SR-2 – STAFF ADVISORY REPORT (03-06-2026)

ADDRESS: 2008 LONGFELLOW

APPLICATION NUMBER: HDC2025-00741

SCOPE: REHABILITATE HOUSE AND GARAGE (WORK STARTED WITHOUT APPROVAL)

Applicant drawings. Above: Façade/front wall. Below: Porch plan.

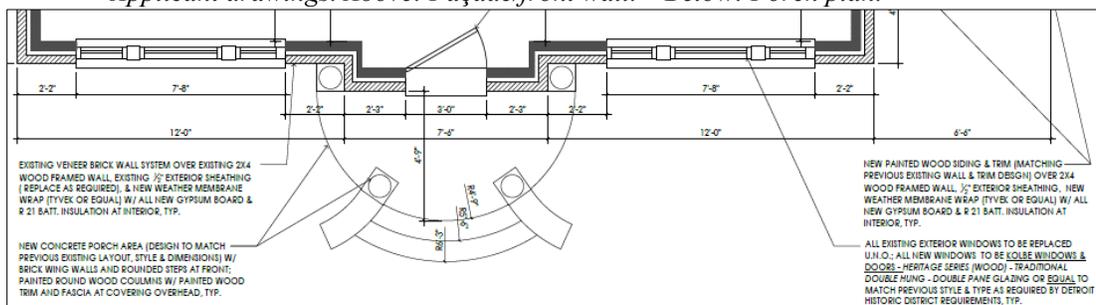
- The proposed portico matches the historic portico, and wood Tuscan columns have been selected. The floor plan shows structural mullions will be built within the multiple window openings. The new wood windows will match the old windows in operation and material. Staff has requested and will continue to require dimensions of existing windows (frames and setback in opening) to compare against the selected windows to confirm an appropriate match. Additional information needed includes the window line within the Heritage Series, glass and screen specifications, muntin profile and dimension, placement/setback in window opening and confirmation that brickmold will be retained.

- Dimensions of one of the remaining historic double-hung window frames, including muntins and recessed dimension from the outer masonry wall, will be submitted to staff.

- Specifications on the selected Kolbe 'Heritage Series' window line be submitted, as will a window order with all details related to the manufacturing be listed (including glass, screens, muntin profile and dimension, etc.).

Applicant drawing of east side wall. Above: Aerial view of house from the rear yard. ConnectExplorer, May 2024.

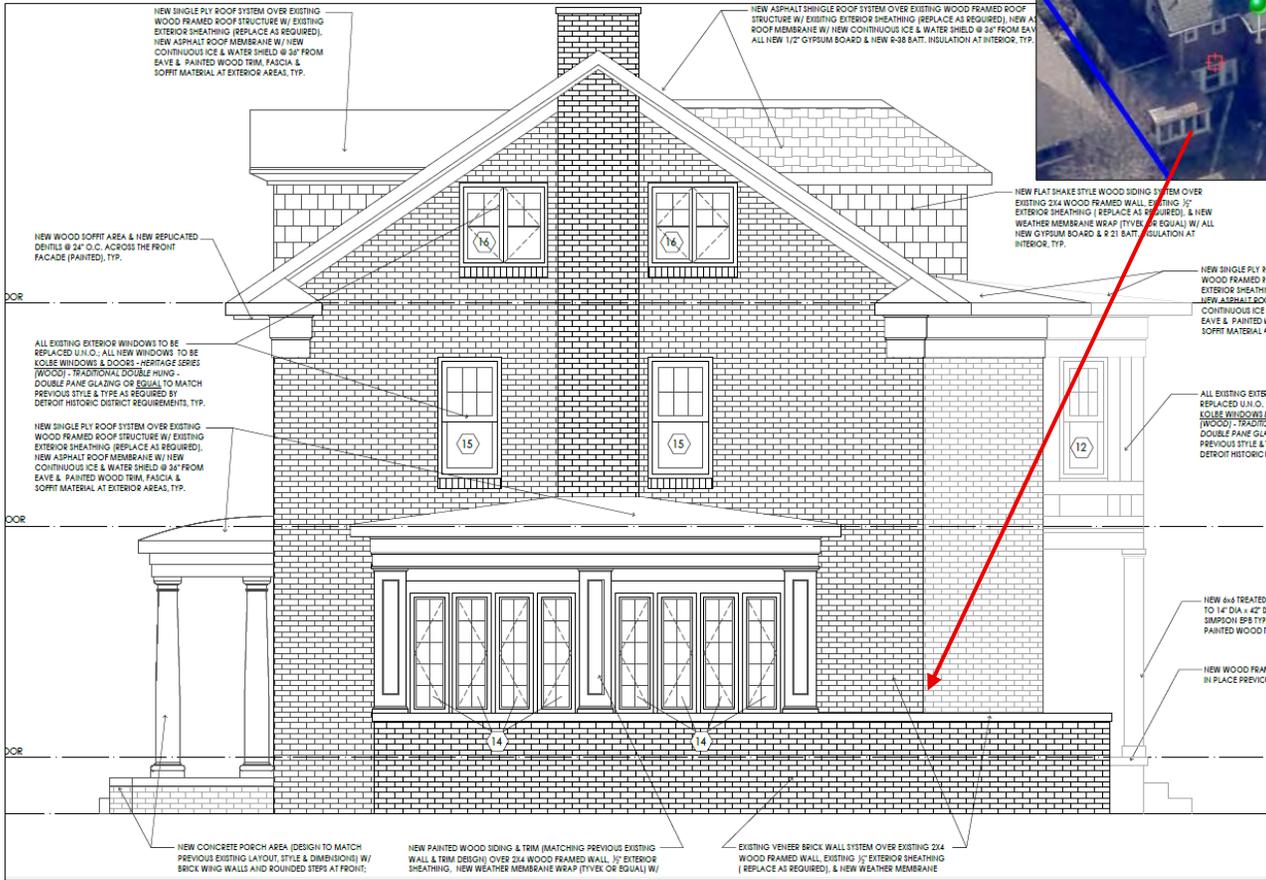
- The historic roof/wall/window structure that enclosed more than half of the side porch was demolished by the applicant, rather than repaired. The applicant proposes to rebuild this feature to match the historic design. Additional demolition work recently completed at the property was the removal of a non-historic enclosure of the remaining porch. Ghost lines remain of the now removed roof structure, showing how it wrapped around the side and rear walls, covering a portion of the downspout. This removal (unlike that of the historic porch enclosure) is an improvement to the property, restoring a historic and character-defining element.

*Above: Photo from thisiscarpentry.com.
Right: Applicant drawing.*

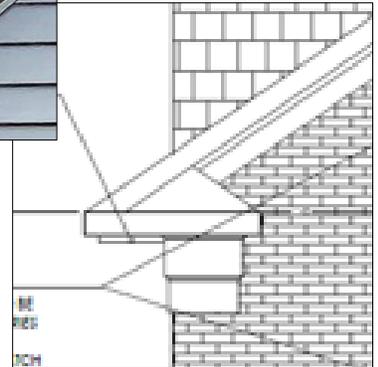
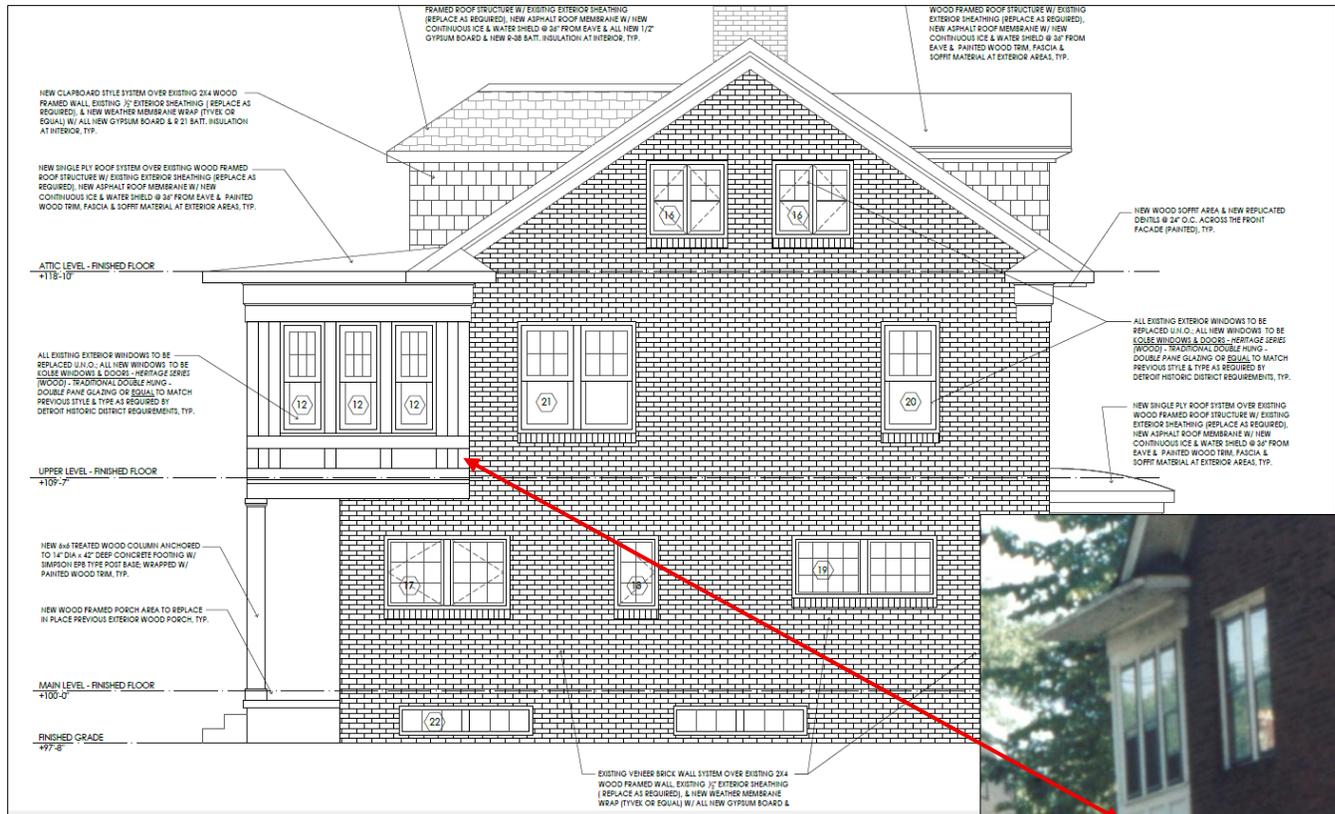
- One detail that staff questions on the drawings is the eave return. Boxed (closed) eaves are a distinctive feature of this house and are historically designed with eave returns to give the effect of a pediment, as seen here, on the east and west gable walls. The returns are covered with flashing to shed water and effectively “disappear” within the shadow of the overhanging eave.

- A common occurrence in new construction, or in poor repair efforts at historic houses, is to build these returns out, i.e., capping them, thus creating a chunky and highly visible element.
- The eave return on the applicant’s drawing is confusing as it doesn’t identify a recessed or forward position as well as its finish/covering. Therefore, it is staff’s interpretation of the drawing that the intention may be to “box out” this detail, like the example provided, which would alter this highly visible, distinctive character-defining feature. The drawings should be amended to clearly note how this detail will be reconstructed, which could also be completed by the creation of a section drawing

- The window/wall panel design at the second story rear porch will be revised to match the historic design and proportions.
- A section drawing or project notes will be added to the drawing set to clarify how the eave returns will be constructed and finished.

Applicant drawing of rear wall.

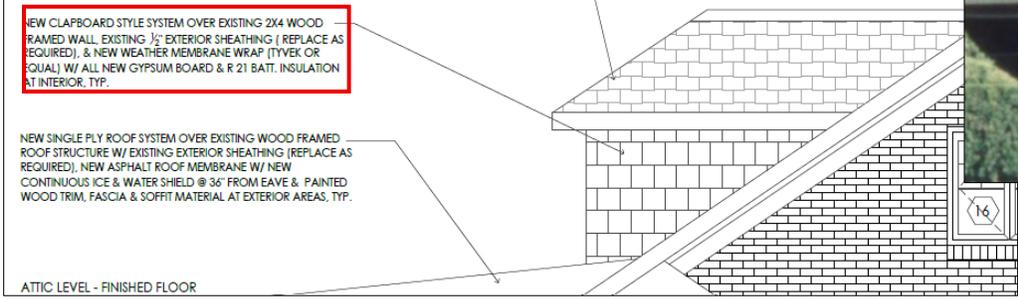
- The applicant's stated intent is to rebuild the rear porch to match the historic design. However, the proportions on the drawing, when compared to a 1974 designation photo, are not duplicative of the original condition.

Shake siding condition.
 Left: Front wall dormer. Staff photo, 01/28/26.
 Right: Rear wall dormer. Staff photo, 02/26/2026.

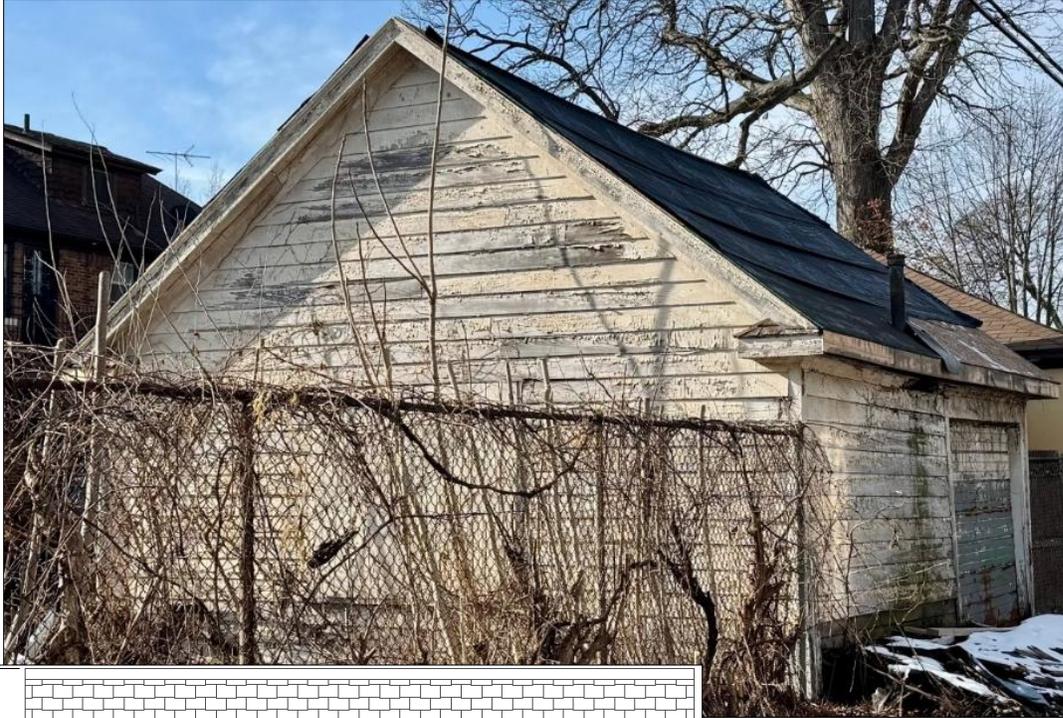
- The drawings state the wood shake shingle siding on the dormers will be replaced with a "new clapboard style system". The shake siding is a historic feature of the house and appears to be in repairable condition. The installation of a replacement siding material does not meet Standard 6.

1. The wood siding at the house and garage date from the period of significance and are distinctive character-defining features of the property.
2. The wood shake and clapboard siding is intact and appears to be repairable. Wood siding is readily available and can be milled to match the exposure, profile and pattern of the historic wood siding and be painted to match the surface finish of the remaining historic wood siding/trim on the house and garage.

Left: Staff photo of east and rear walls of garage (taken from alley). 02/26/2026. Below: Applicant drawings.

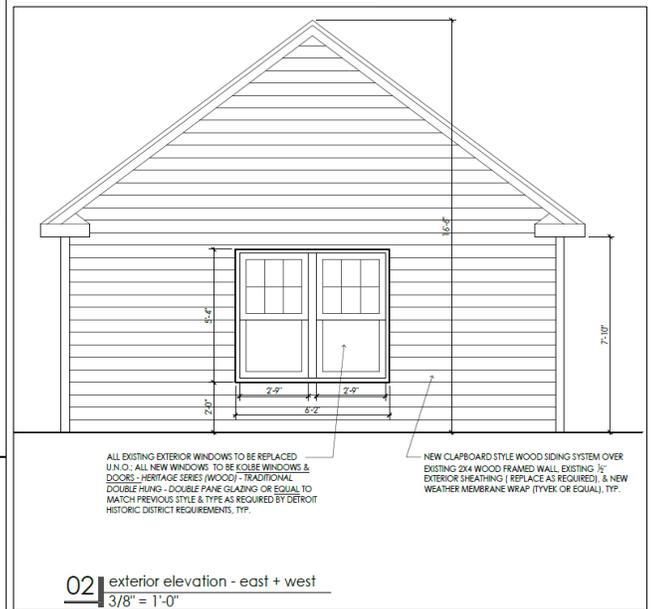
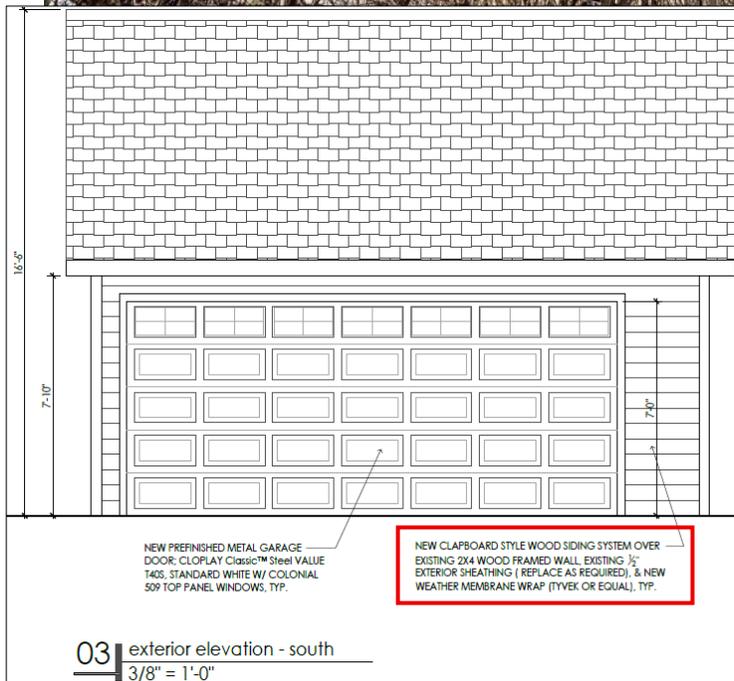
- According to the building permit, the garage was erected the same year as the house (1919). The deep boxed eaves, mullied window openings, side gable roof and eave returns, match details found on the house and are distinctive character-defining features. Staff identifies the garage as a contributing structure within the historic district.
- Similar to the house’s dormers, a proposed work item specifies “new clapboard style wood siding system” to be installed on the garage walls. The historic wood siding and trim are intact and in repairable condition. Even if some replacement boards are necessary, wood siding is readily available and can be purchased/milled to match the exposure and profile of the historic wood siding.
- Staff offers similar concerns on the illustration of the eave returns, as discussed on the house’s gable walls.
